Green Line Implementation New Park at Macpherson Avenue and Davenport Road

What We Heard

Phase 1 – Concept Plan Options

February 2021

6. Concept Plan Option 1 – Flow

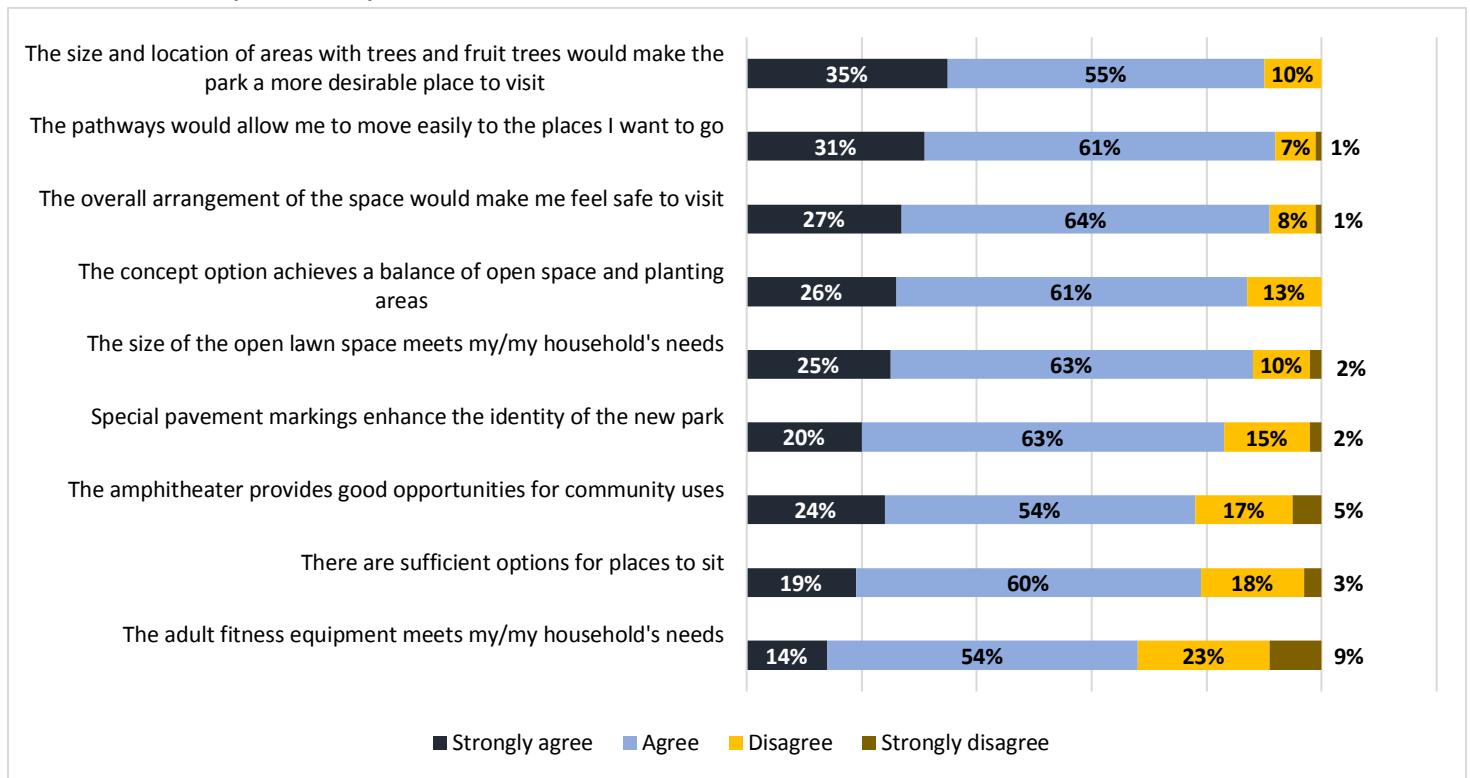
2.5.1 Option 1 – Flow

Specifically, in Option 1, participants indicated the following:

- This option's overall organization provides a more organic experience and is unique compared to the angular arrangement of Option 2.
- The amphitheatre is appealing and a unique feature for the park but should be carefully considered for its utility given how much space it takes up.
- This option creates two distinct "rooms" with apparent uses for the amphitheatre and open lawn area.
- The dense patch of trees in this option presents a potential safety hazard after dark by reducing sightlines.
- The arrangement of benches in this option creates small private spaces for people to sit.

7. Concept Plan Option 2 – Striation

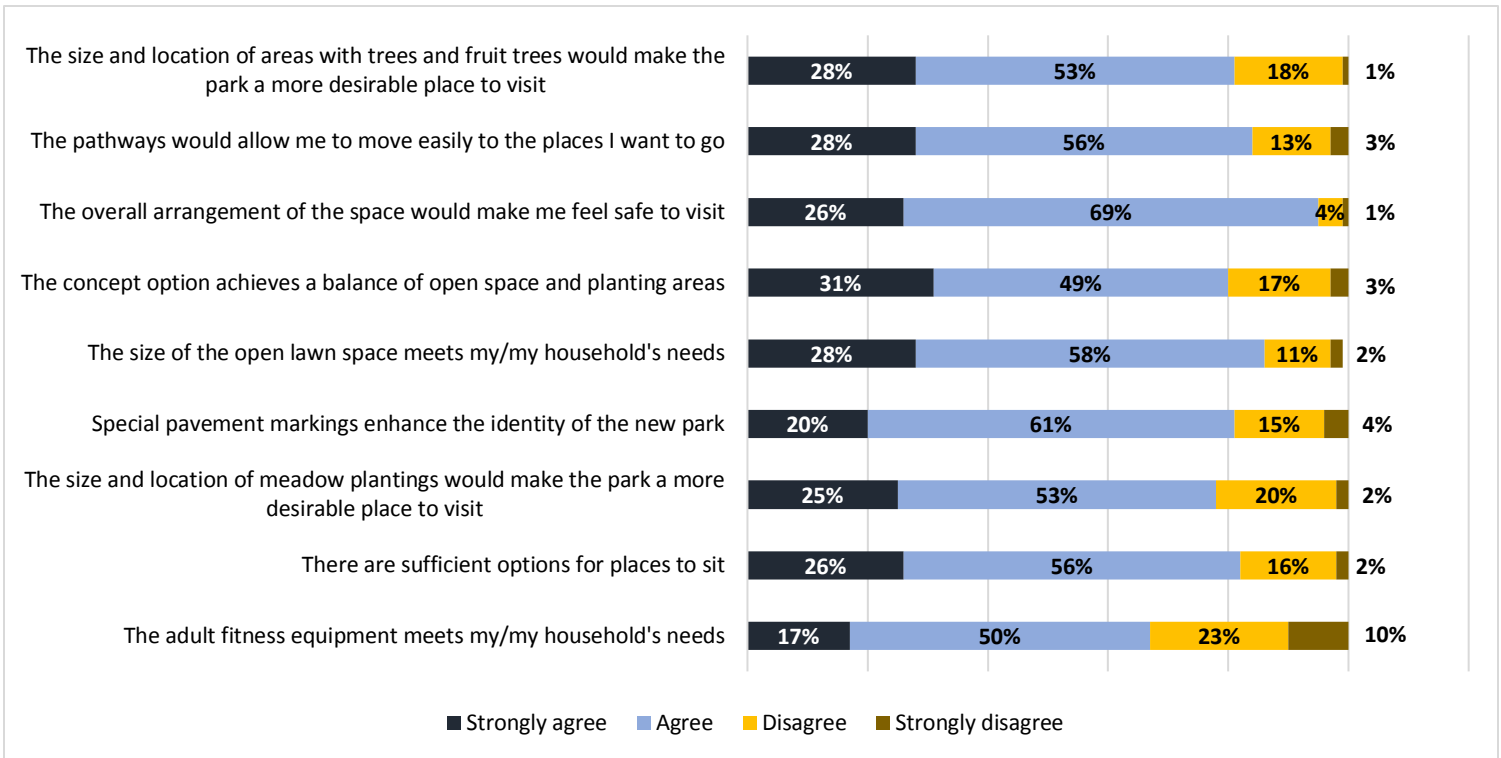
2.5.2 Option 2 – Striations

- The overall organization of this option is less unique than Option 1 but has better sightlines.
- There is a better balance of tree and meadow areas and seating throughout the park in this option than Option 1. Trees spread-out throughout the site will provide better sightlines and safety.
- The scattered boulders provide an interesting and creative way to connect the area's geological history to the park while giving the flexibility for various uses such as seating, play, and visual intrigue.
- Ground-level lights could be used to light the areas with the rocks.
- The wider T-intersection in this option and striation paving pattern helps open up this part of the path.
- The pavement loop near Davenport and the CP tracks in the southeast corner paves over valuable green space for an additional lawn or meadow space.
